**RE: Primrose School
Grading Plan
Engineer's Stamp Date: 05/04/18
Hydrology File: C13D029**

Based upon the information provided in your resubmittal received 05/04/2018, the Grading Plan **is not** approved for Building Permit and Grading Permit. The following comments need to be addressed for approval of the above referenced project:

Grading Plan

**RE: PRIMROSE SCHOOL
GRADING PLAN
HYDROLOGY FILE: C13D029**

PRIMROSE SCHOOL OF NW ALBUQUERQUE GRADING PLAN	DRAWN BY pm DATE 5-1-18 DRAWING
	SHEET # 4	JOB # 2017092
ENGINEER'S SEAL RONALD R. BOHANNAN P.E. #7868		TERRA WEST, LLC 5571 MIDWAY PARK PL NE ALBUQUERQUE, NEW MEXICO 87109 (505) 858-3100 www.tierrawestllc.com

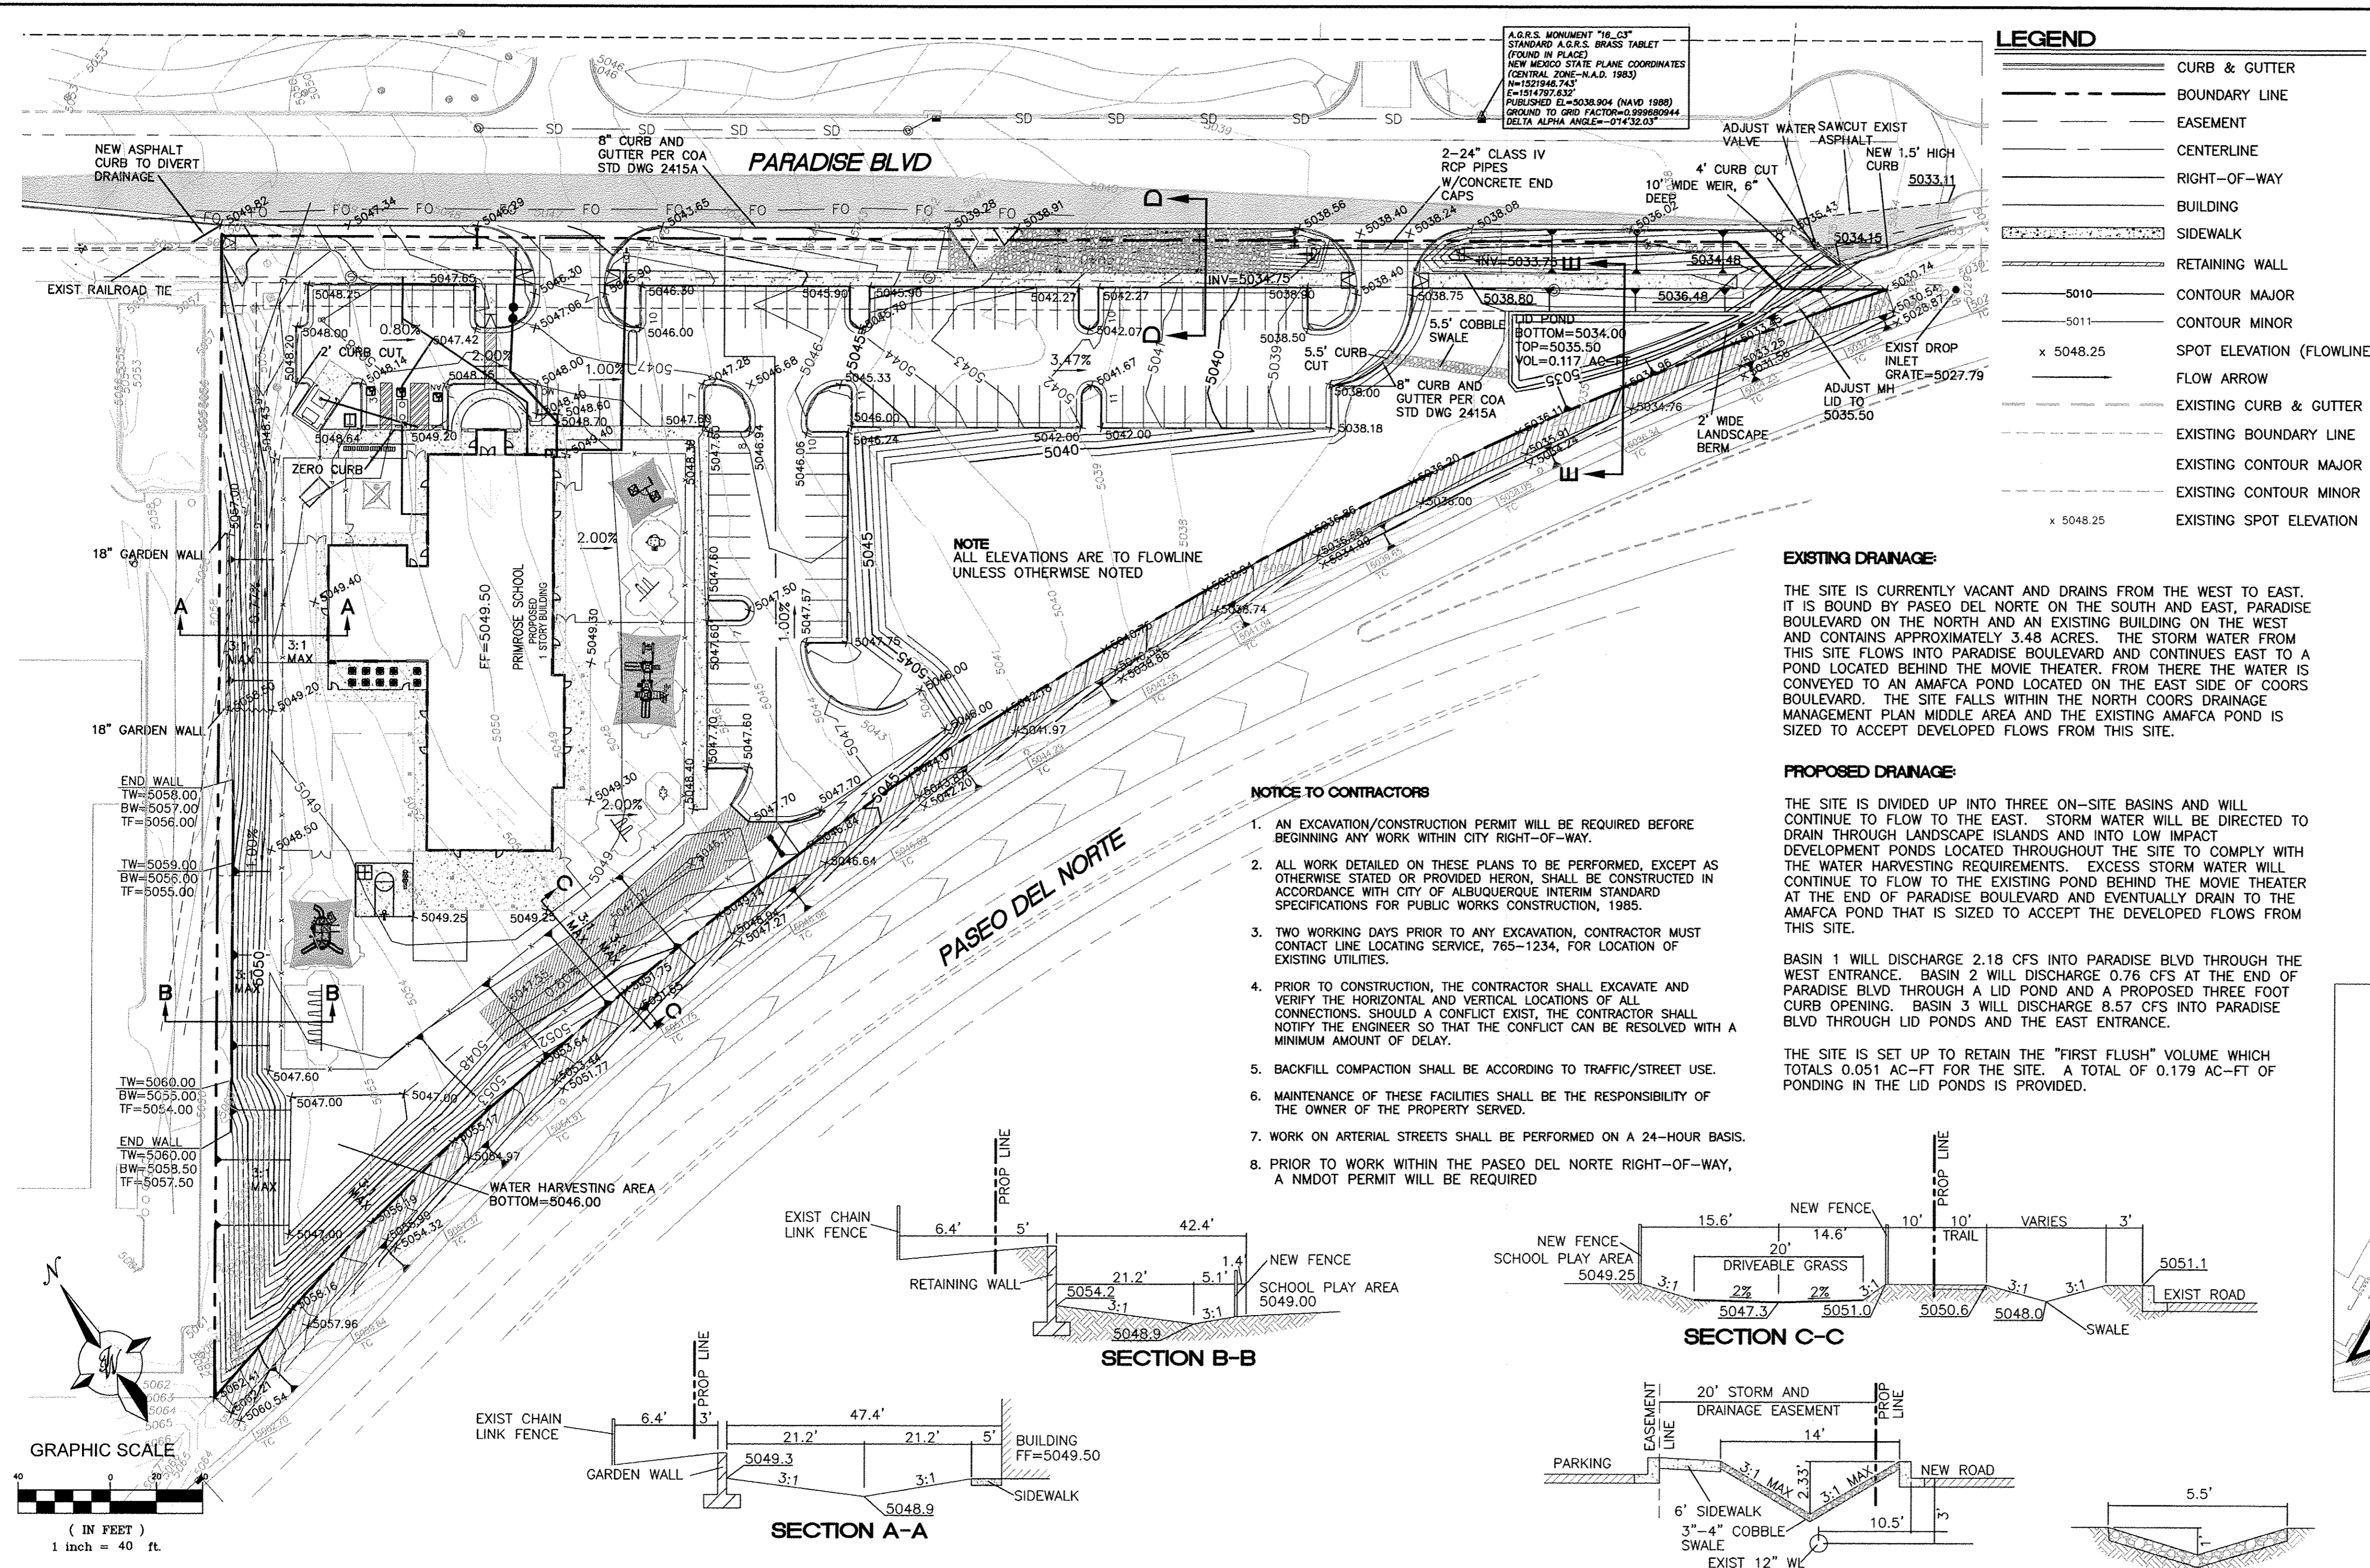
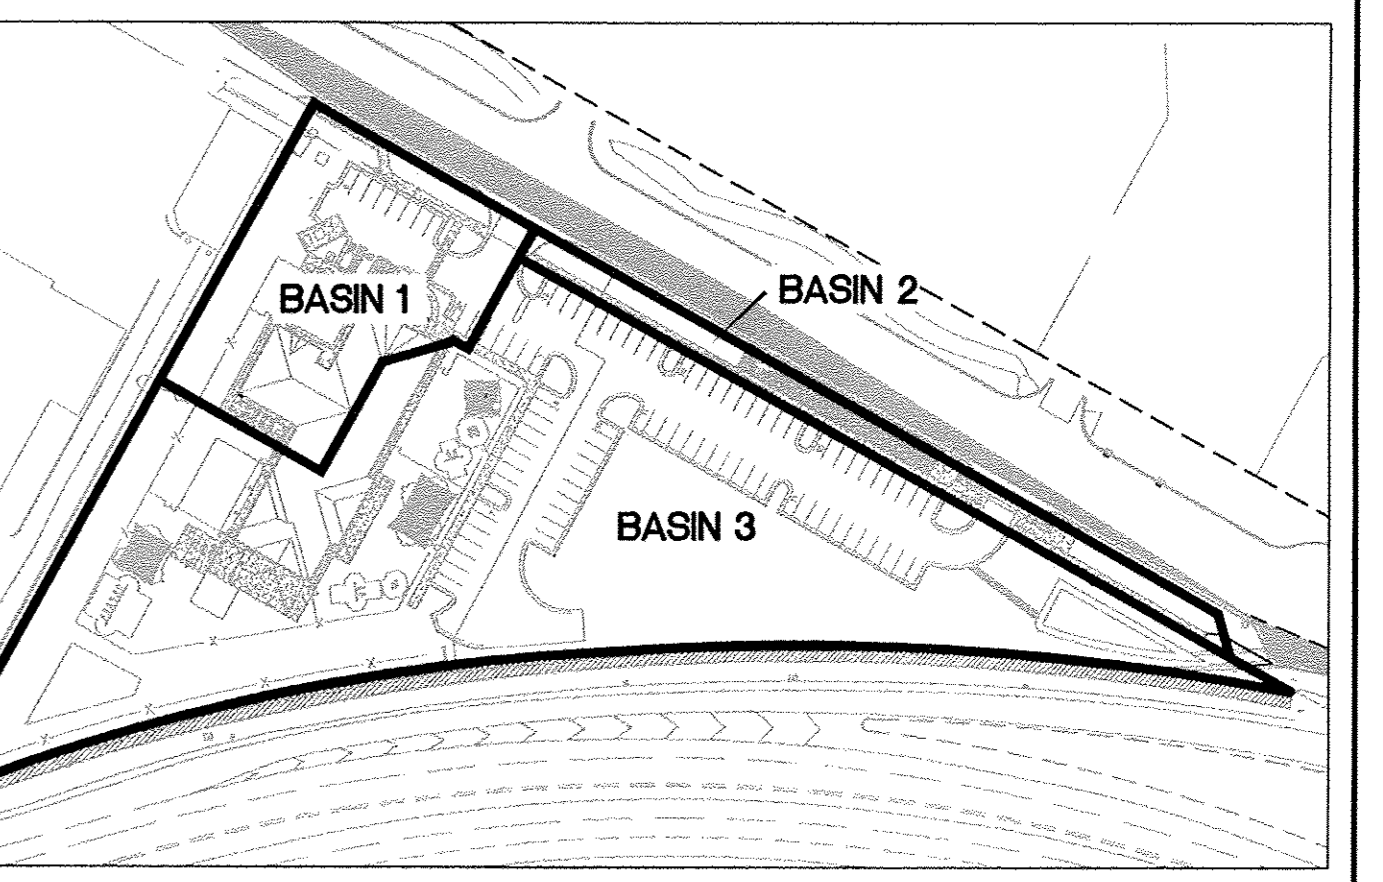
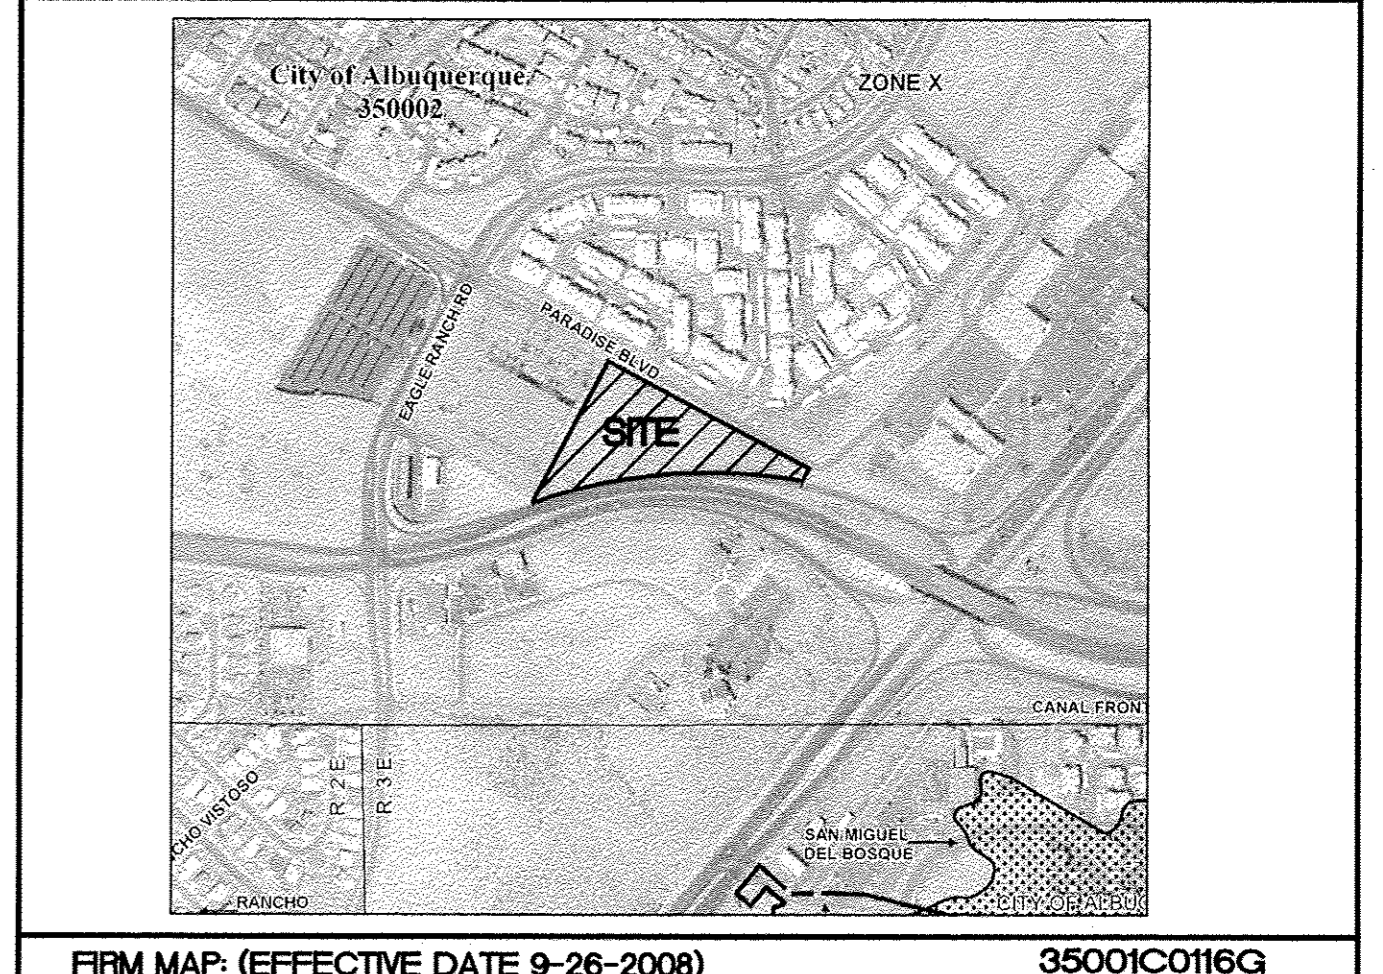
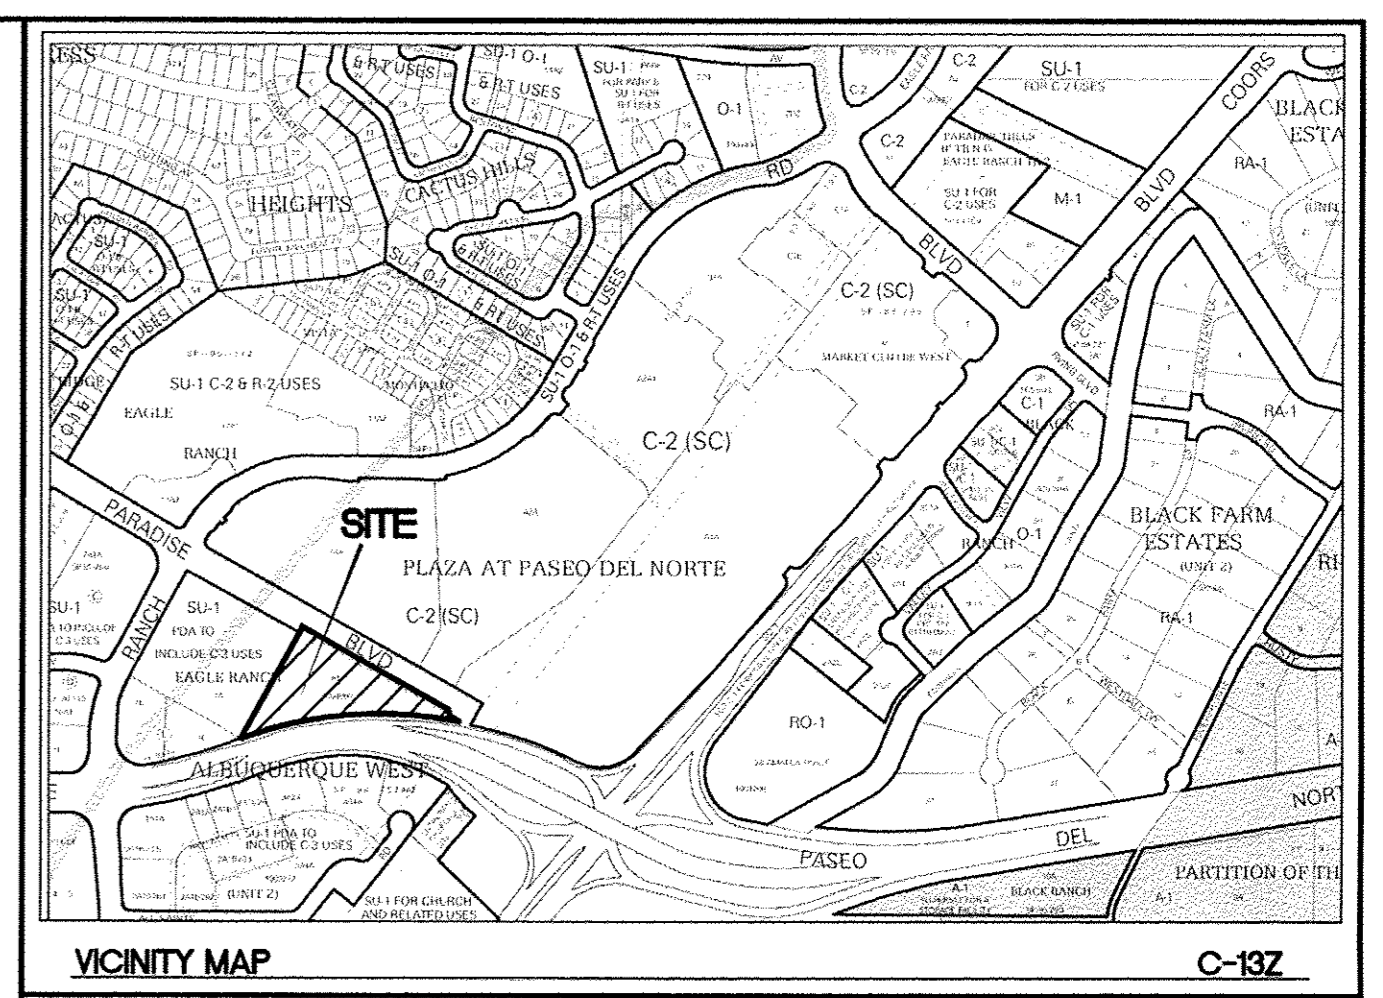
1. Please add the thickness and size of the riprap in the private cobble swale detail.
2. Please provide a detail of the 10' wide 6" deep weir at the LID pond outfall. Also please provide weir calculations for this 10' weir.
3. I noticed you have a curb and gutter transition for Transportation on Paradise Blvd. However the drainage from the church and drainage swale adjacent to the roadway has not been addressed with this proposed curb and gutter. The drainage will pond in front of the PNM transformer. This needs to be addressed somehow on the Grading Plan.

7. Please show existing top of curb information along Paseo Del Norte at least at 50 feet apart. **The top of curb elevations were added to the Grading Plan.**

8. Please show the existing drop inlet drainage information within Paseo Del Norte. **The grate elevation for this inlet is now shown on the plan.**
9. Please provide proposed elevations at both edges of the 10ft asphalt trail, top of bank, flow line, and top of bank at 50 feet intervals along the southern property line. **These elevations are now shown on the Grading Plan.**

10. There are missing grades within the proposed parking areas. Please provide them. **Additional spot elevations were added to the parking areas.**
11. Please indicate if the proposed spot elevations within the proposed parking area are the top of curb or flow line information. **All spot elevations are flowline unless otherwise indicated. A note to this effect was added to the Grading Plan.**

12. What is the purpose of the 20' Drivable grass? If it is for fire protection, then the firetrucks can only drive on a 2% max slope. Please fix. **It is for fire access and the slope was adjusted to be 2%.**

13. Please correct the first flush calculation to 2,234 CF instead of 2.234 CF. **This typographical error was corrected.**
14. Please provide the weir calculation for the 3ft curb cut. **The weir calculation is included in Appendix "C" of the Drainage Report. The swale and opening were changed to 5.5' wide.**

15. Please provide a typical section of the 3 ft. cobble swale. **A cross section for the cobble swale was added to the plan.**
16. Please provide proposed top of curb along Paradise Blvd. **Top of curb elevations were added along Paradise Blvd.**

20. Please provide a section from Paradise Blvd. through the LID pond to Paseo Del Norte. **This cross section was added to the Grading Plan.**
21. Please fix the outfall spillway for the LID pond. This should outfall into the street of Paradise at a proper angle so that the drainage is directed to the existing concrete rundown. **The angle of the spillway was changed to direct the water to the existing concrete channel.**
